Access Compliance Report Public Rights-of-Way (RR Crossings)

Intersection ID: 53713	Main Street: N_TRYON_ST	Location: N/A
ADA ID: C6D405F051B4	Overall Compliance: No	Severity Score: 0.0
Codes/Mitigation Info/Possible Solution		Field Measurements/Component Compliance

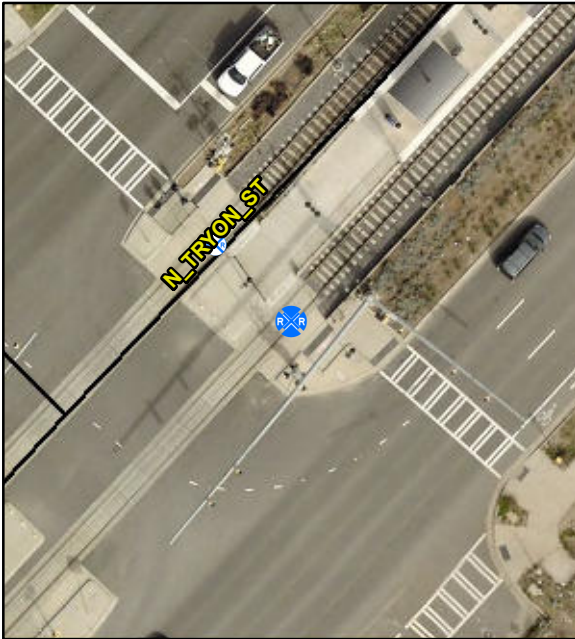
**Remove & Replace Detectable
Warning System. Provide Pedestrian
Gate. Remove & Replace Walking
Surface Adjacent to Rail.**

R302.7.4, R305.2.5

Compliance	Description	Data
Yes	DWS Provided?	Yes
Yes	DWS Contrast?	Yes
Yes	DWS Width (in)	Yes
Yes	DWS Length (in)	24.0
No	DWS Offset (in)	65.0
No	Pedestrian Gate?	No
N/A	DWS Outside Gate?	Yes
N/A	Rail Type?	LightRail
No	Flangeway Gap (in)	2.5
Yes	Sidewalk Width (in)	121.0
